## **ADDENDUM 03**

### **DELAWARE TECHNICAL & COMMUNITY COLLEGE ALLIED HEALTH – C-WING ADDITION & RENOVATIONS**

**Project Name:** Delaware Technical & Community  
College – Allied Health, “C” Wing  
Addition & Renovation

**Subject:** **ADDENDUM 3**

# **ADDENDUM #3** **DETAIL 3 - ENLARGED PLAN** **FIRE PROTECTION - BASE BID**

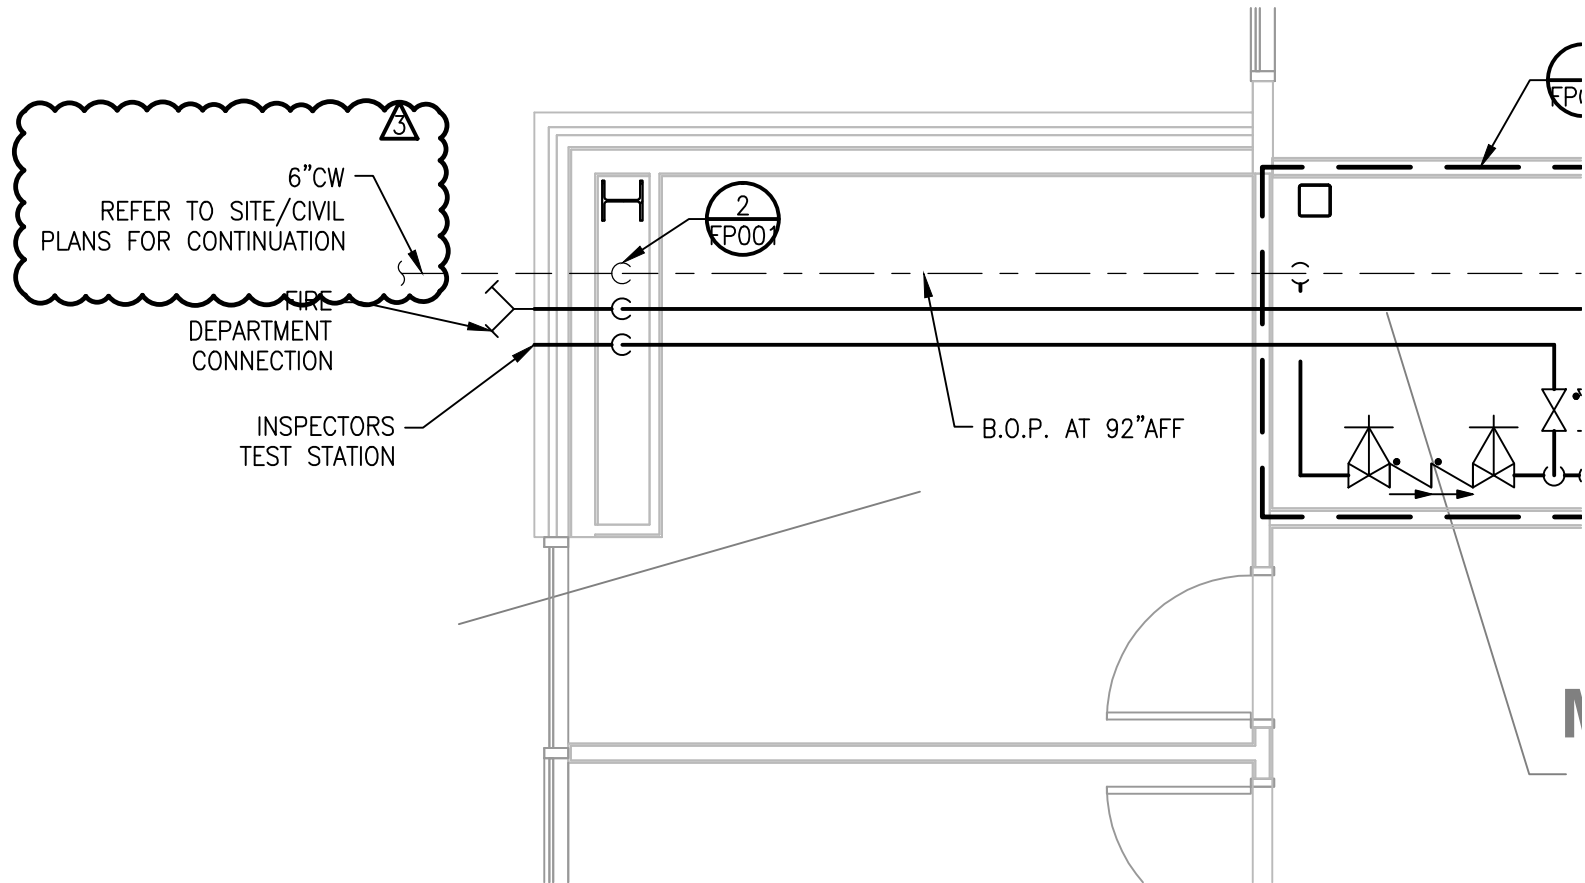
| Item No. | Description:  |
|----------|---|
| D-1      | <b>Drawing FP-101 – General Notes and Details:</b><br><br>a.) <b>Detail 3/FP101:</b> Provide 6” incoming water service. Refer to Engineer’s Supplemental Sketch <b>FPSK-001</b> .<br>b.) <b>General Notes:</b> Remove General Note #7. Refer to Engineer’s Supplemental Sketch <b>FPSK-001</b> .                                |

| Reference: | E113-A3 | Sheet: | ESK-001 |

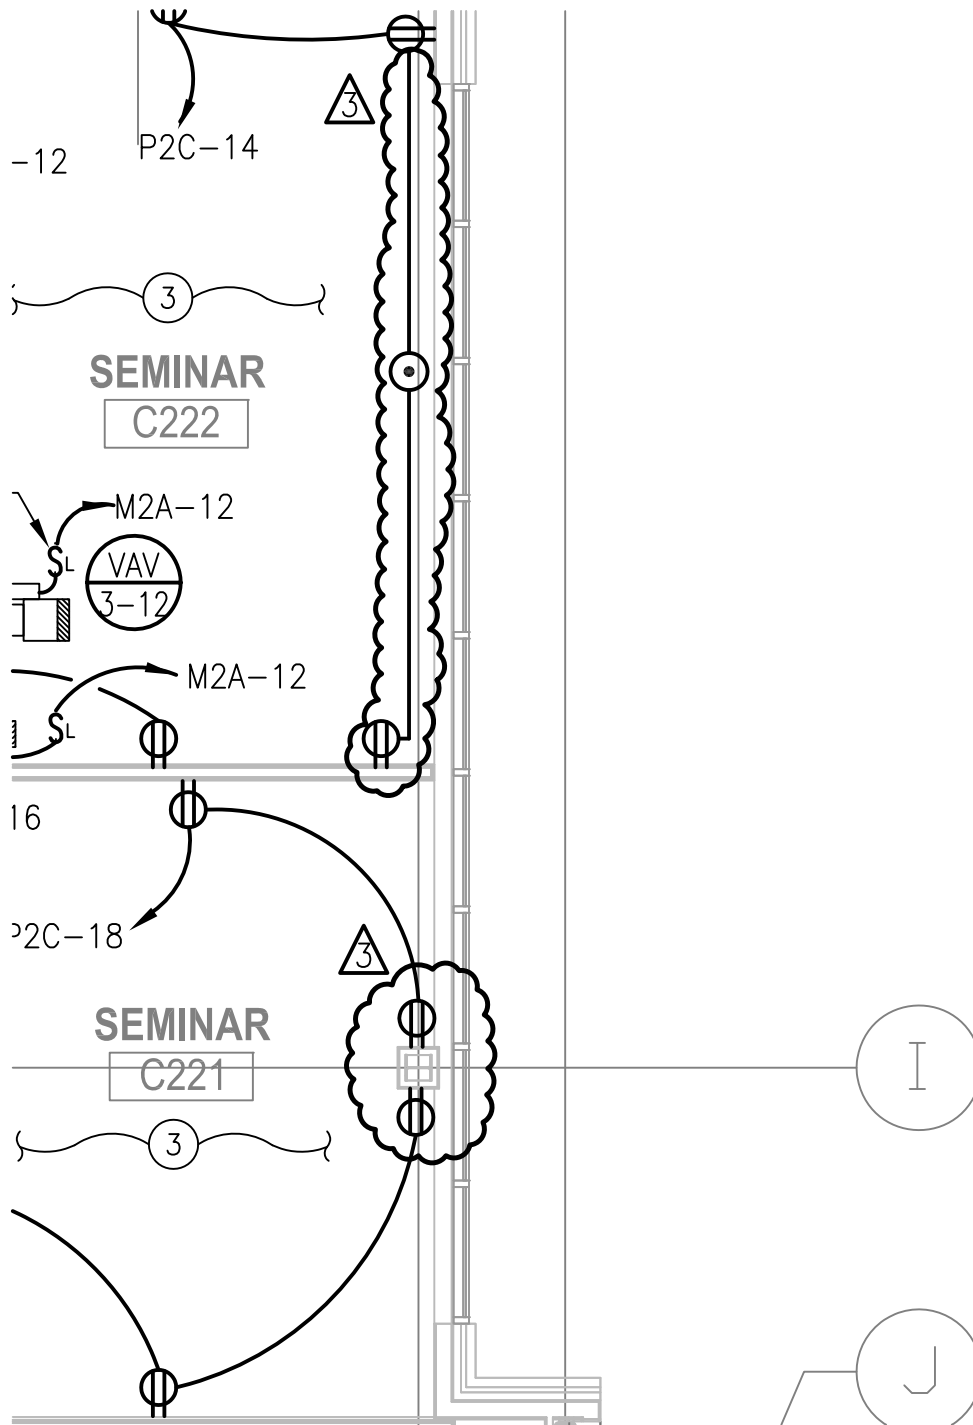
| <b>D-18</b> |  | <p><b>Drawing E113-A3 – 2<sup>ND</sup> Floor New Work – Power Plan – Alt.3</b></p> <p>a.) relocated a few receptacles and added one floor box, see clouded affected devices Refer to Engineer’s Supplemental Sketch <b>ESK-001</b>.</p>  |

| Reference: | E113 | Sheet: | ESK-003 |

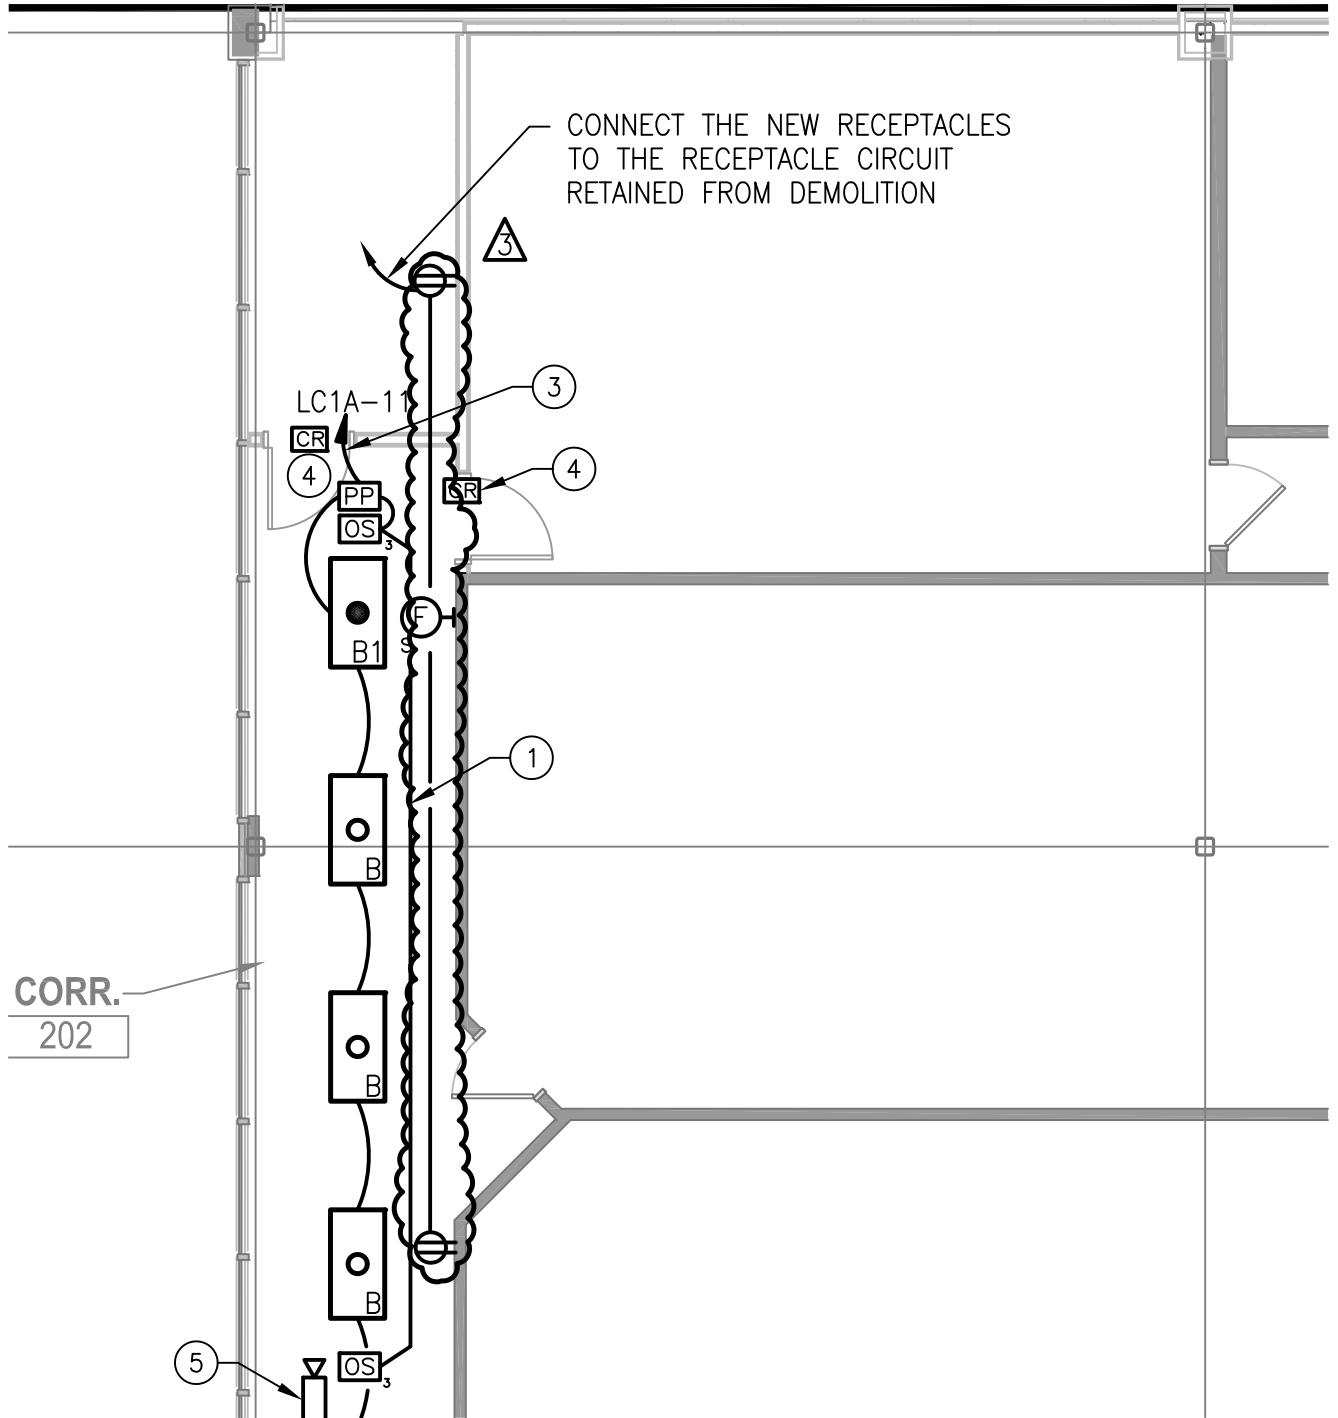
| <b>D-20</b> |  | <p><b>Drawing E113 – 2<sup>ND</sup> Floor New Work – Power Plan – Base</b></p> <p>a.) relocated a few receptacles, see clouded affected devices Refer to Engineer’s Supplemental Sketch <b>ESK-003</b>.</p>  |

Reference: **E114-A6** Sheet: **ESK-005**

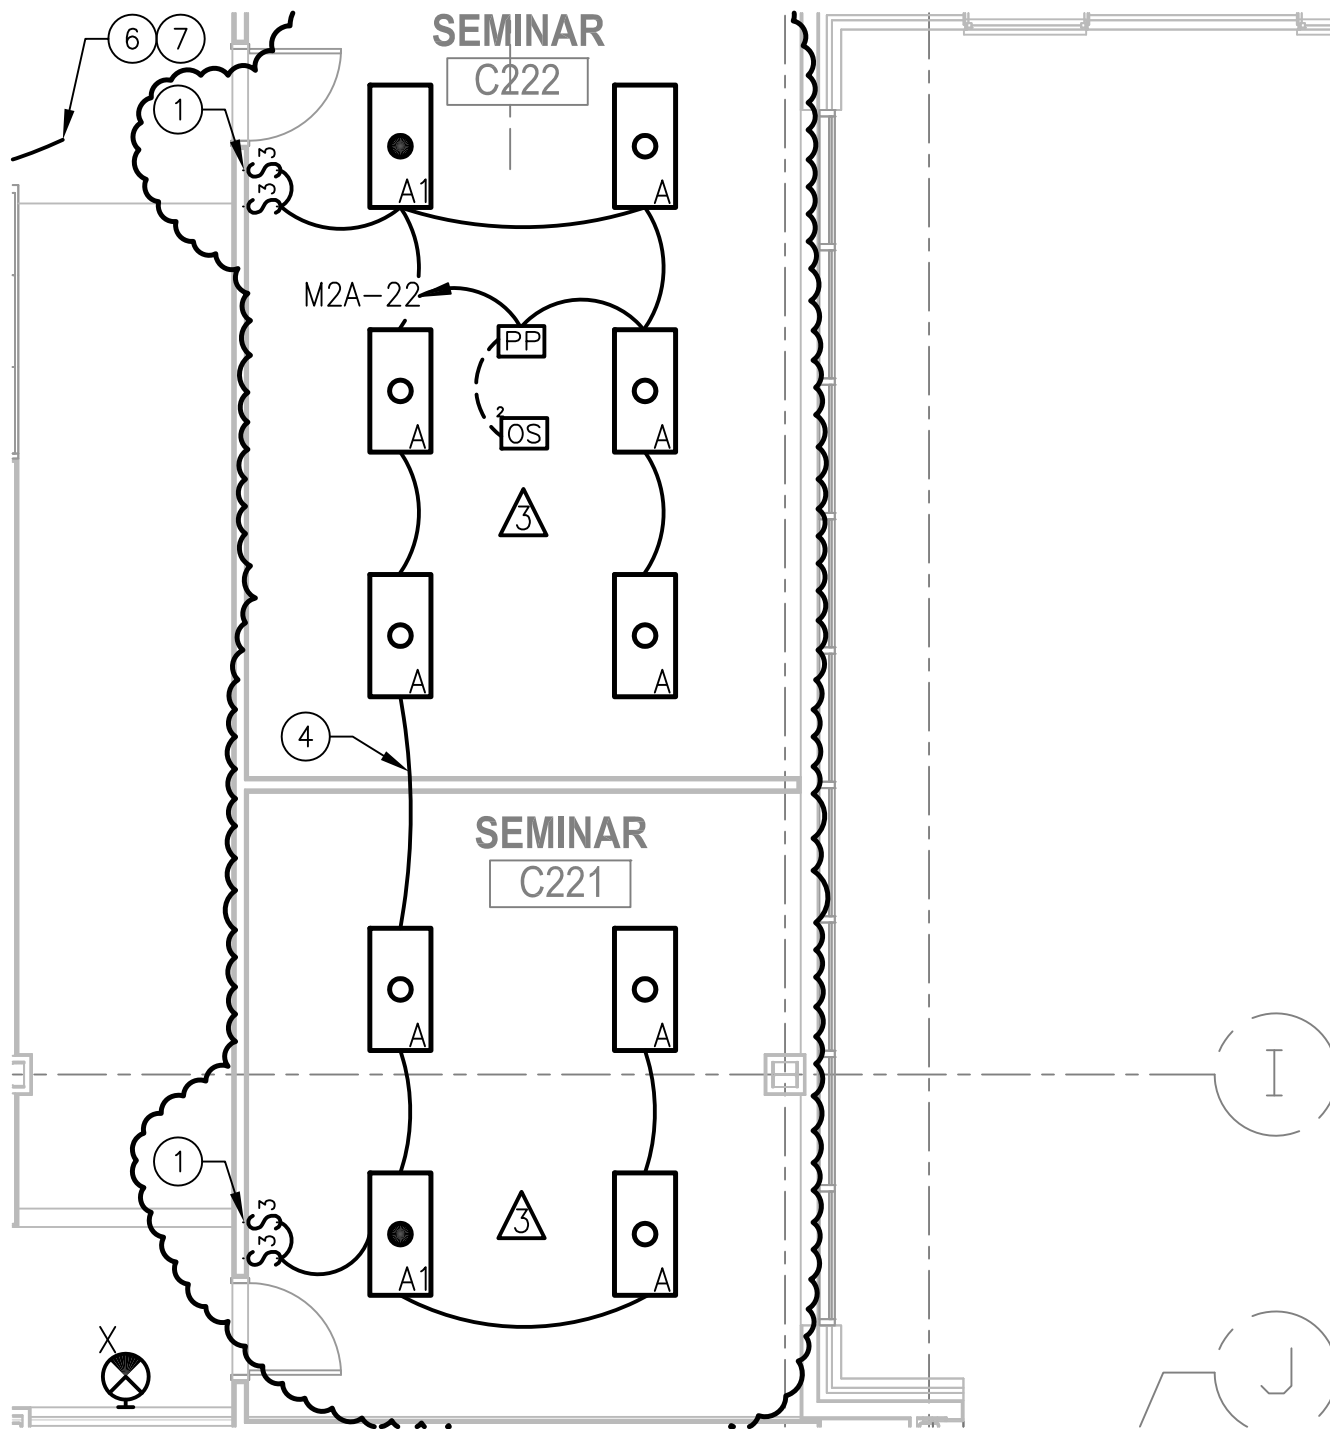
| <b>D-22</b> |  | <p><b>Drawing E114-A6 – 2<sup>ND</sup> Floor New Work – Power Plan – Alt.6</b></p> <p>a.) Deleted one general receptacle in room C285, deleted one receptacle in room C288 and replaced both with a floor box receptacles. Conf. room C289 added three floor box and associated home run, use spare breakers in assigned panel. see clouded affected devices Refer to Engineer’s Supplemental Sketch <b>ESK-005</b>.</p> |

| Reference: | E123-3A | Sheet: | ESK-007 |

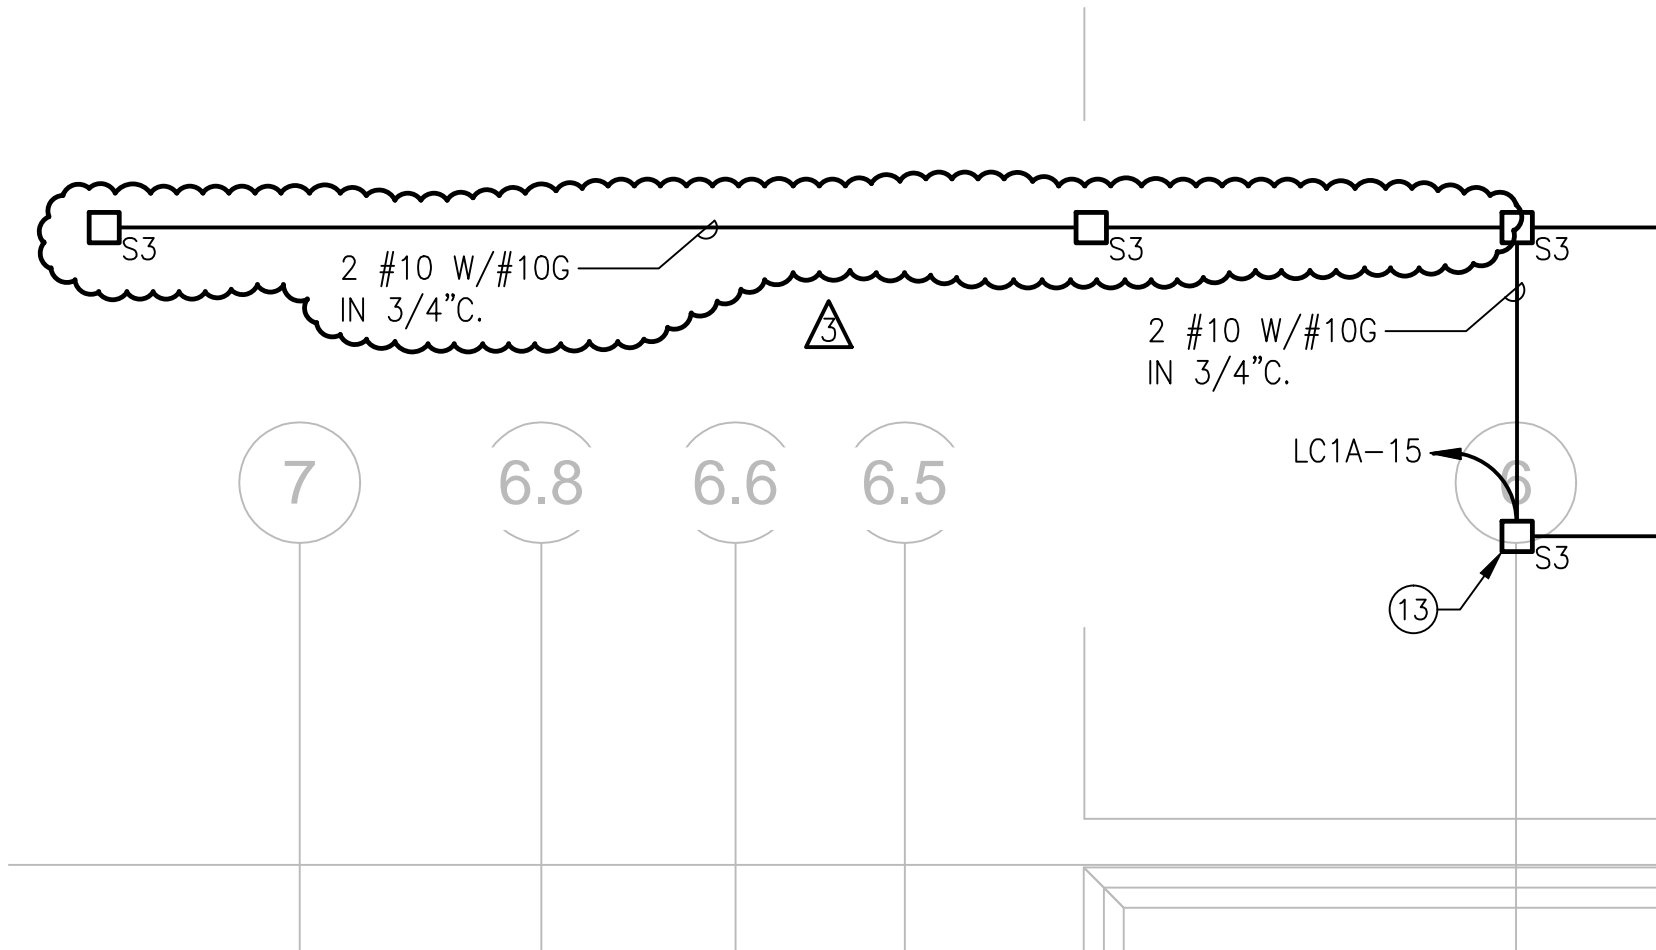
| <b>D-24</b> |  | <p><b>Drawing E123-A3 – 2<sup>ND</sup> Floor New Work – Lighting Plan – Alt.3</b></p>  |

| Reference: | E121 | Sheet: | ESK-008 |

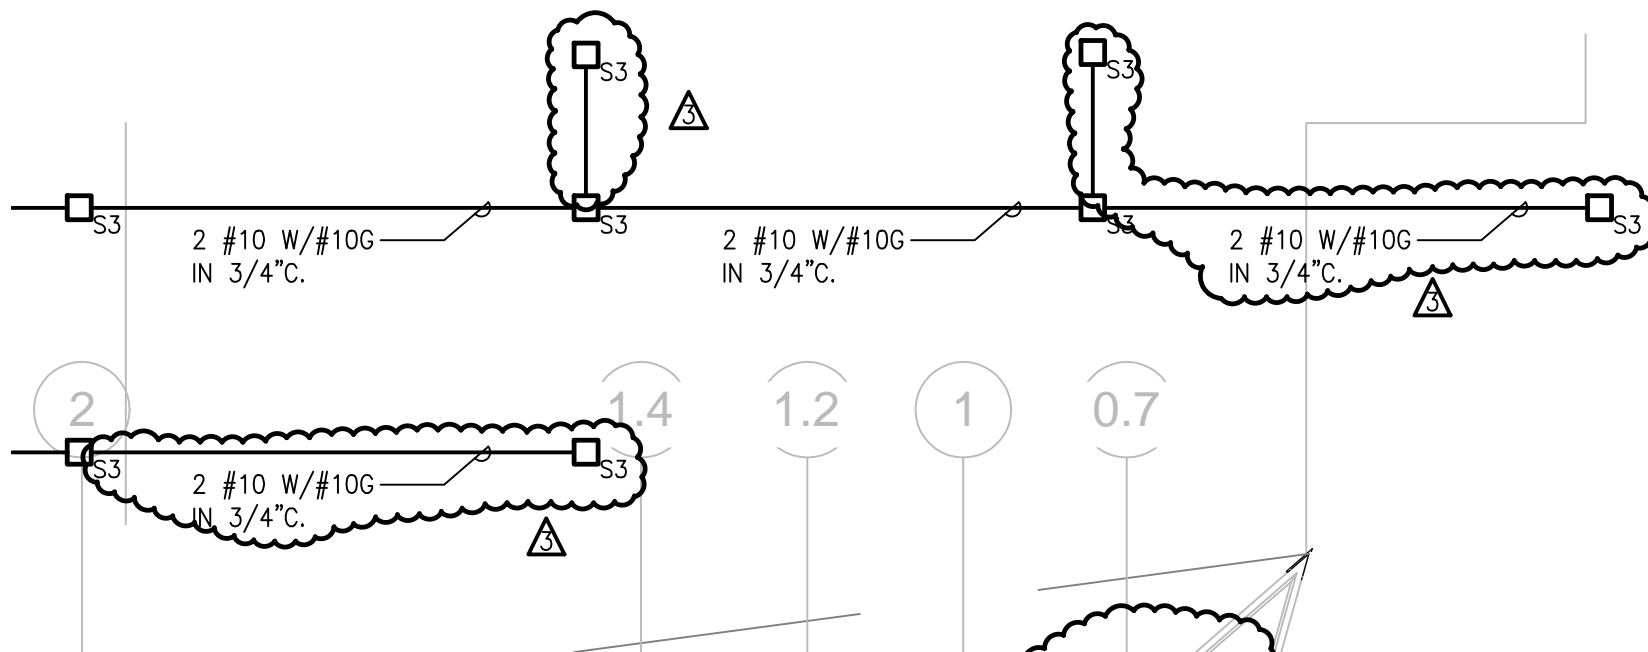
| <b>D-25</b> |  | <b>Drawing E121 – 1<sup>st</sup> Floor New Work – Lighting Plan – Base</b><br><br>a.) Added two (2) lighting fixture types (S3) and associated wiring and conduit, see clouded affected devices Refer to Engineer’s Supplemental Sketch <b>ESK-008</b> .<br>b.) Added four (4) lighting fixture types (S3) and associated wiring and conduit, see clouded affected devices Refer to Engineer’s Supplemental Sketch <b>ESK-009</b> .<br>c.) Deleted six (6) lighting fixture type (S2) and associated wiring and conduit. Re-worked the remaining sixteen (16) lighting fixture type (S2) and associated wiring and conduit, see clouded affected devices Refer to Engineer’s Supplemental Sketch <b>ESK-010</b> . |
